### **INSTRUCTIONAL BULLETIN NO. 17-14**

### **Regarding Revised, New, and Voided Standard Drawings**

Effective March 23, 2018 letting (January 10, 2018 Turn-in), the following Standard Drawings have been revised or created. Also, Chapter 5 of the Roadway Design Guidelines has been revised to incorporate these changes.

|              |           | EVISION FHWA<br>L NOT REQUIRED.          |
|--------------|-----------|--|
| NOT TO SCALE | 3-01-12   | D-PE-24A                                 |

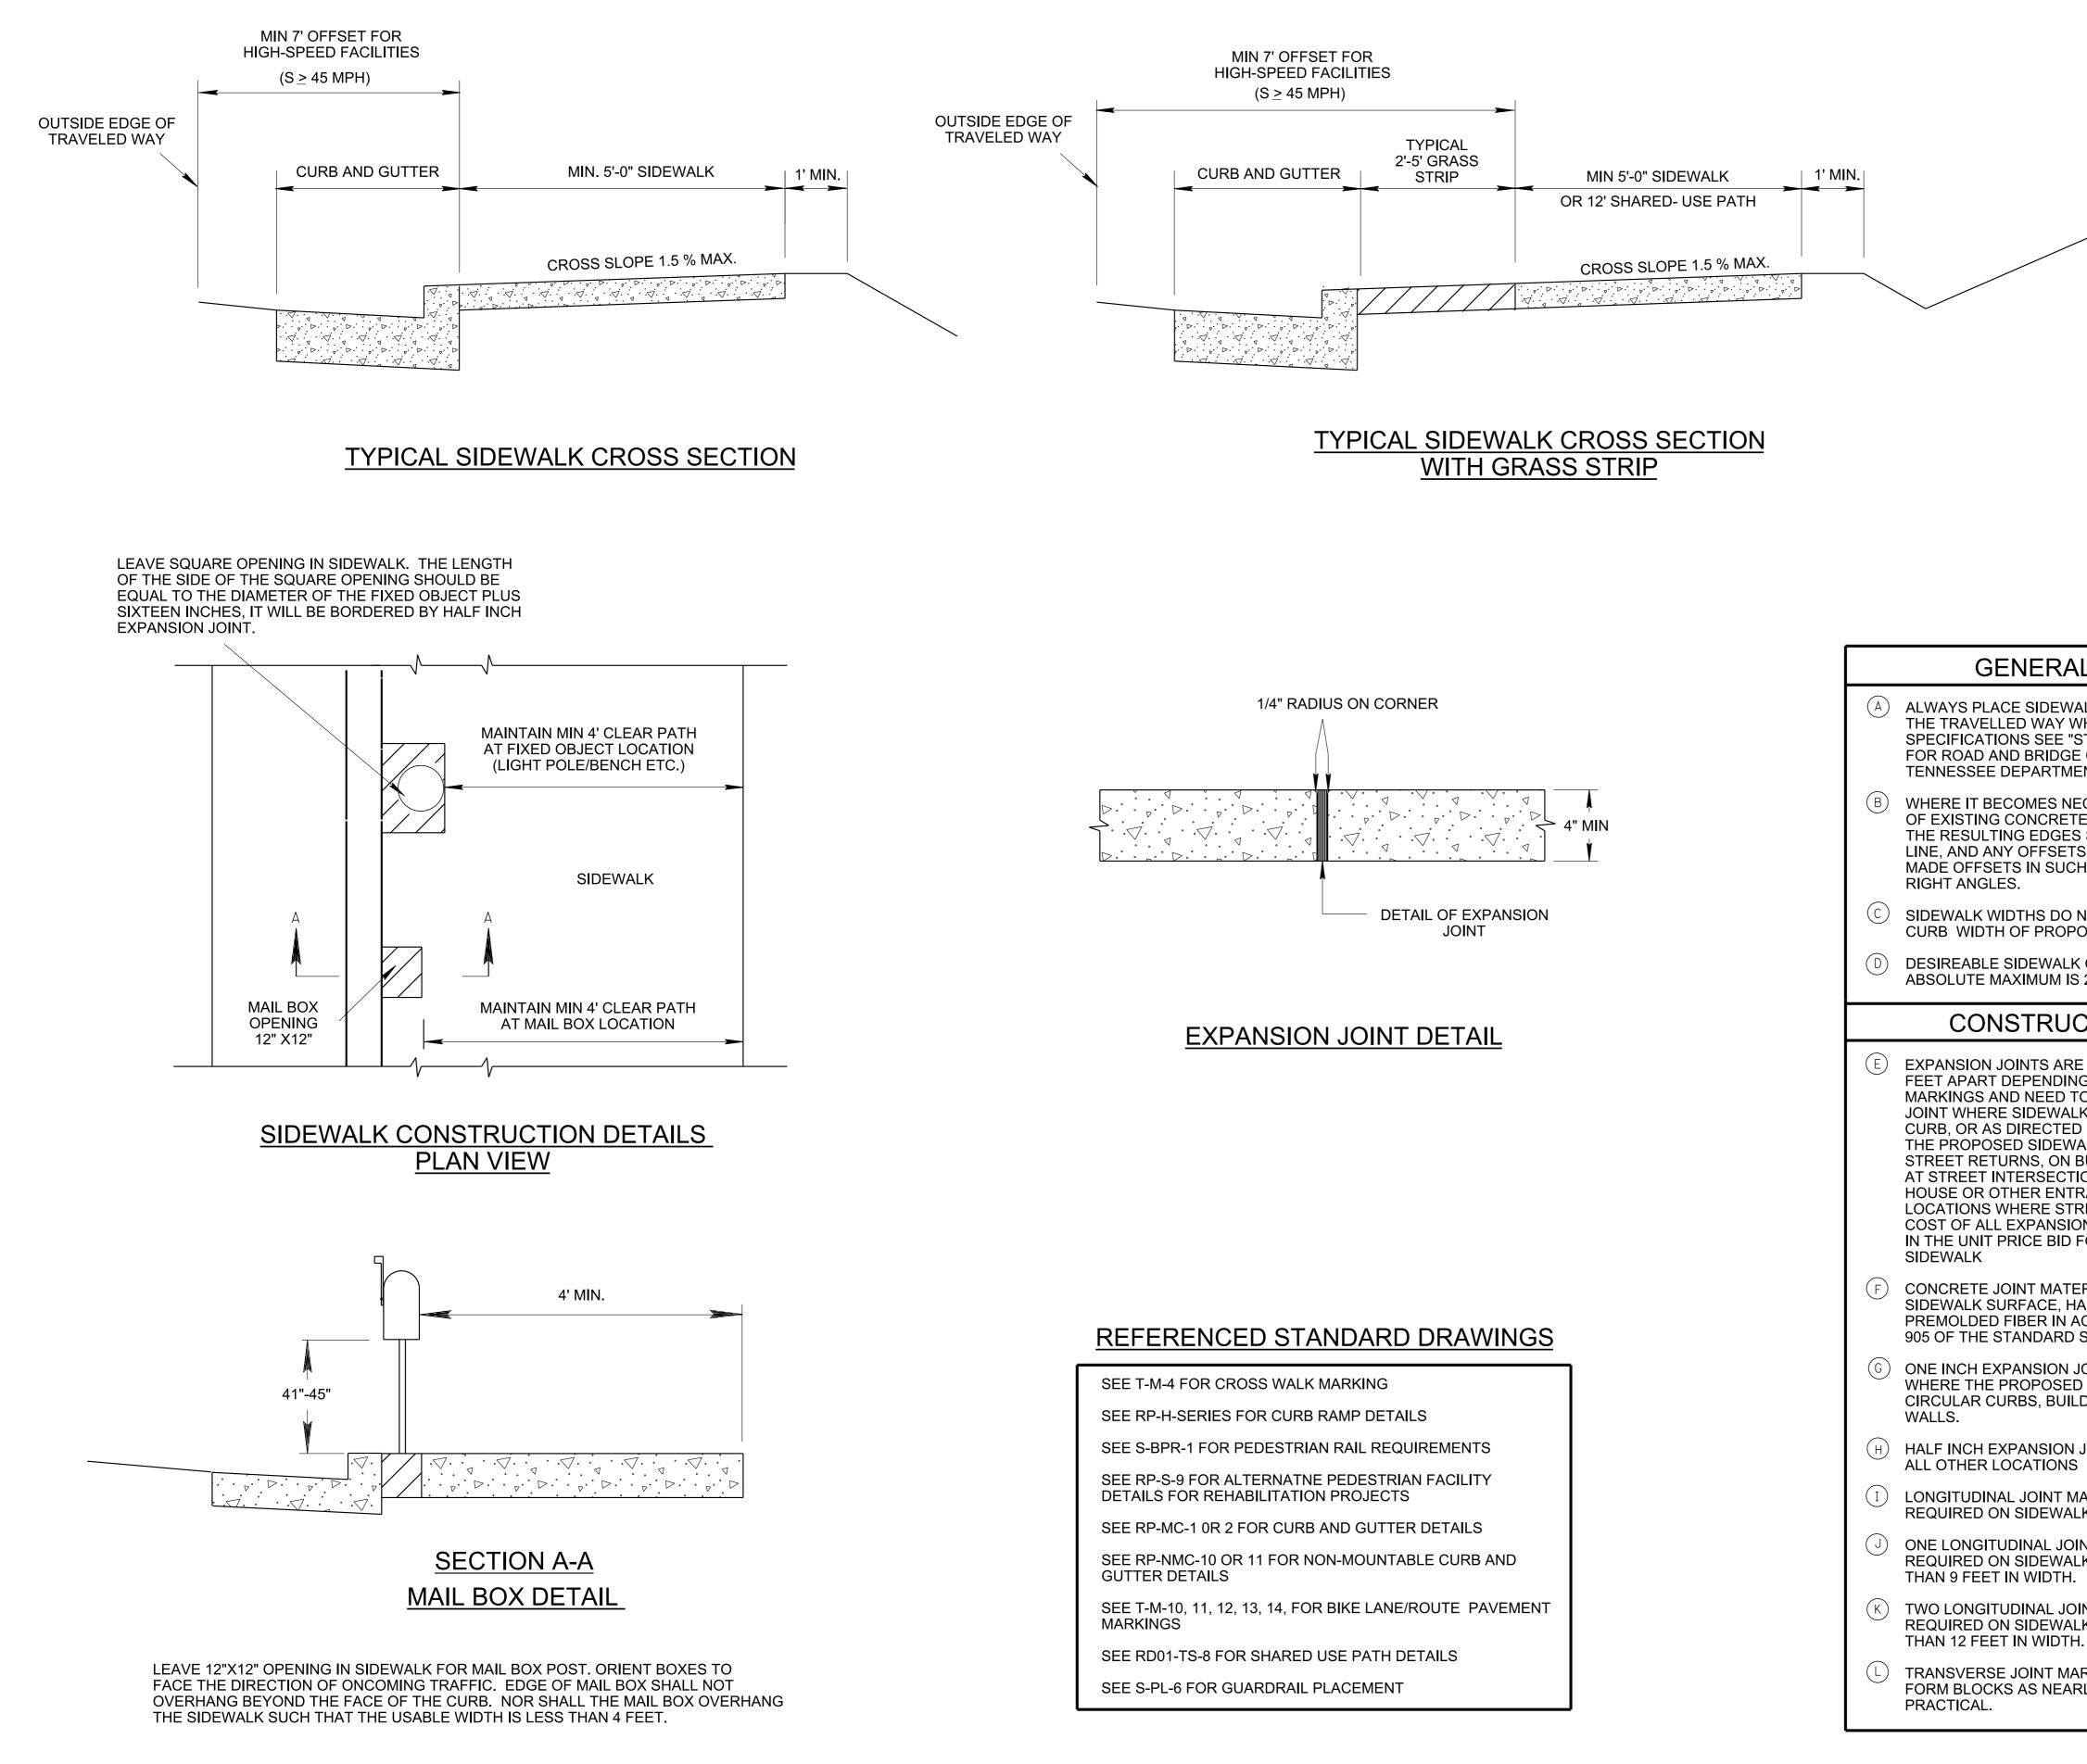
- REV. 6-14-13: REVISED NOTEG. ADDED NOTE HAND I.
- REV. 1-6-15: REVISED HOLE OPENING SIZE. ADDED STEPPED HOLE DETAIL.
- REV. 1-21-16: REVISED GENERAL NOTEB.
- REV. 7-5-17: MODIFIED GENERAL NOTES C AND J.

|   | EVISION FHWA<br>L NOT REQUIRED. |  |
|---|---------------------------------|--|
| 1-19-96 <b>RP-S-7</b>                                 |                                 |  |

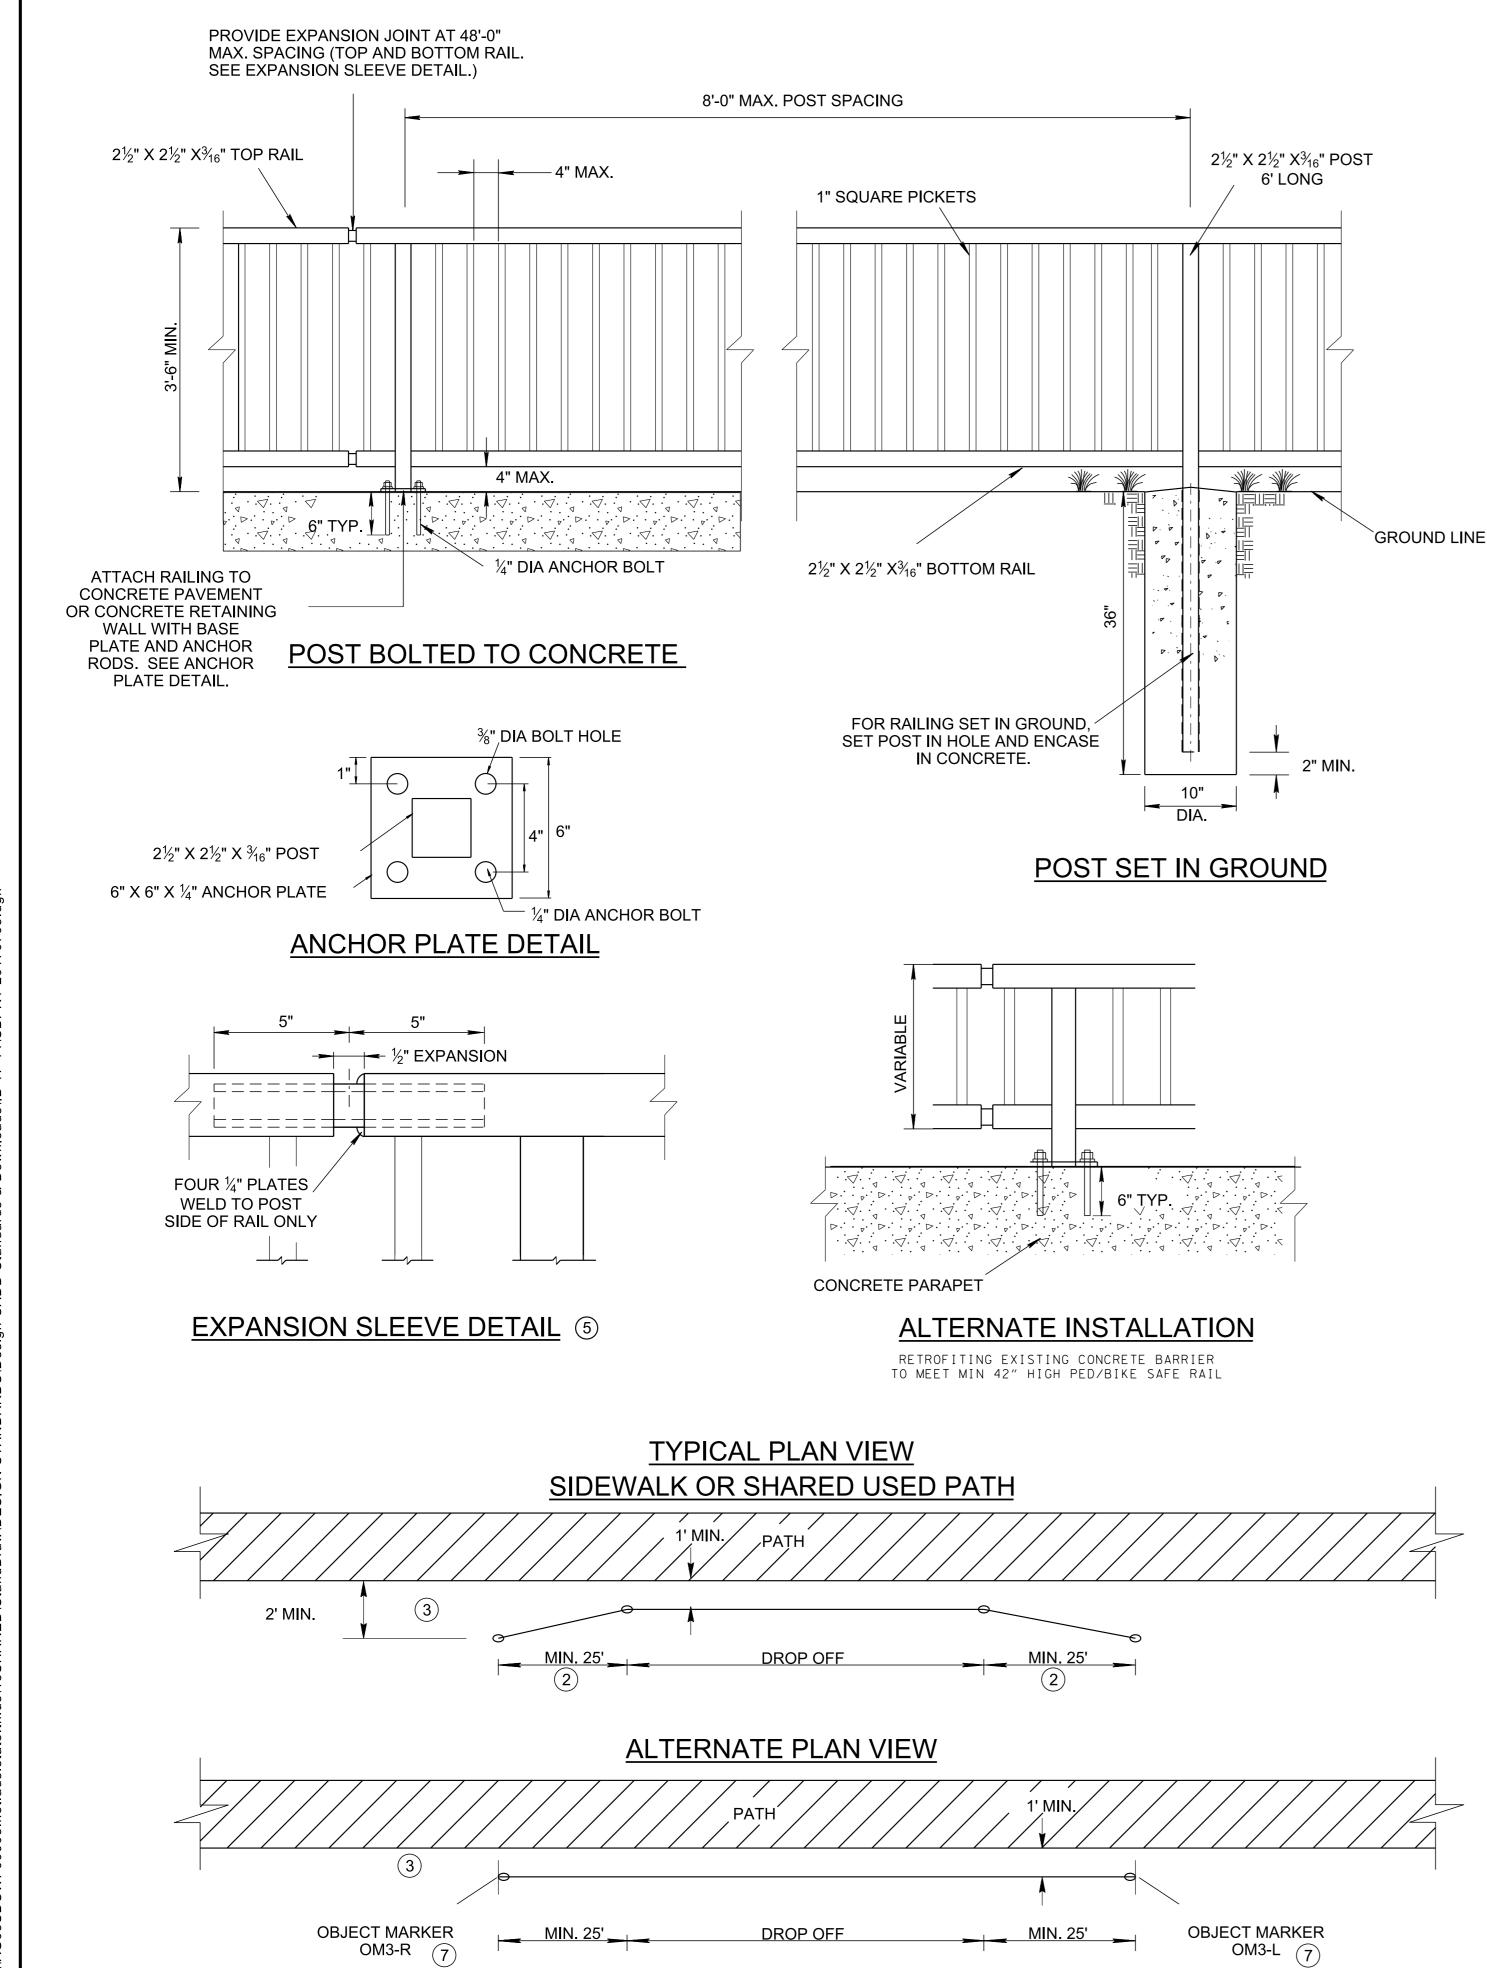
- REV. 7-29-96: CHANGED GENERAL NOTE G
- REV. 5-7-13: ADDED MAIL BOX DETAIL.
- REV. 6-4-13: REVISED NOTES CAND GAND ADDED NOTE(L.)
- REV. 11-25-13: REVISED NOTE 2. REV. 2-5-16: REDRAWN, REVISED NOTES.
- REV. 7-5-17: MODIFIED TYPICAL CROSS SECTION.

|   | EVISION FHWA |  |
|---|--------------|--|
| 7-11-13   | S-BPR-1      |  |

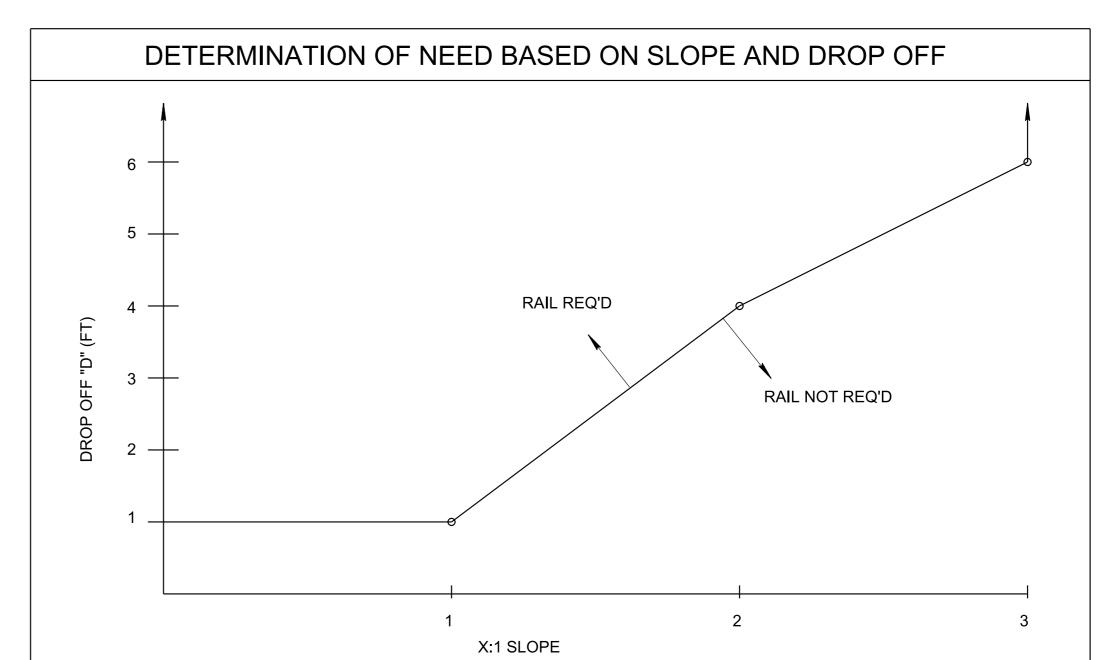
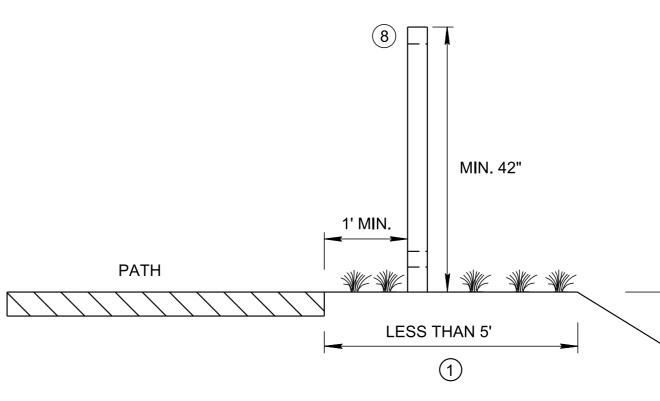
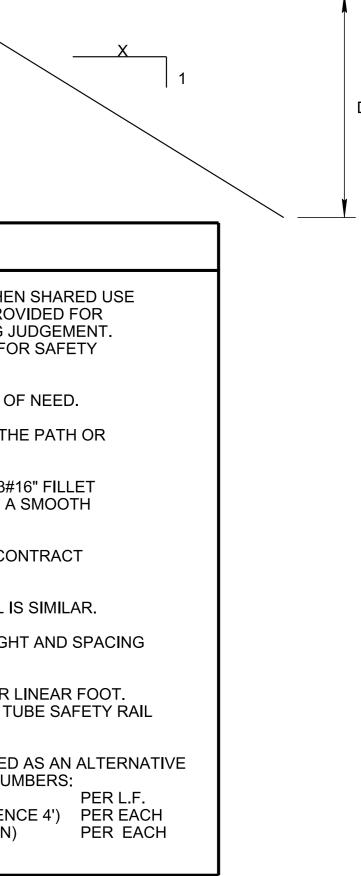
- REV. 6-4-14: CHANGED PAY ITEM NO. REV. 2-5-16: ADDED ALTERNATE INSTALL DETAIL.
- REV. 7-5-17: MODIFIED GENERAL NOTES. ADDED GENERAL NOTE (8).
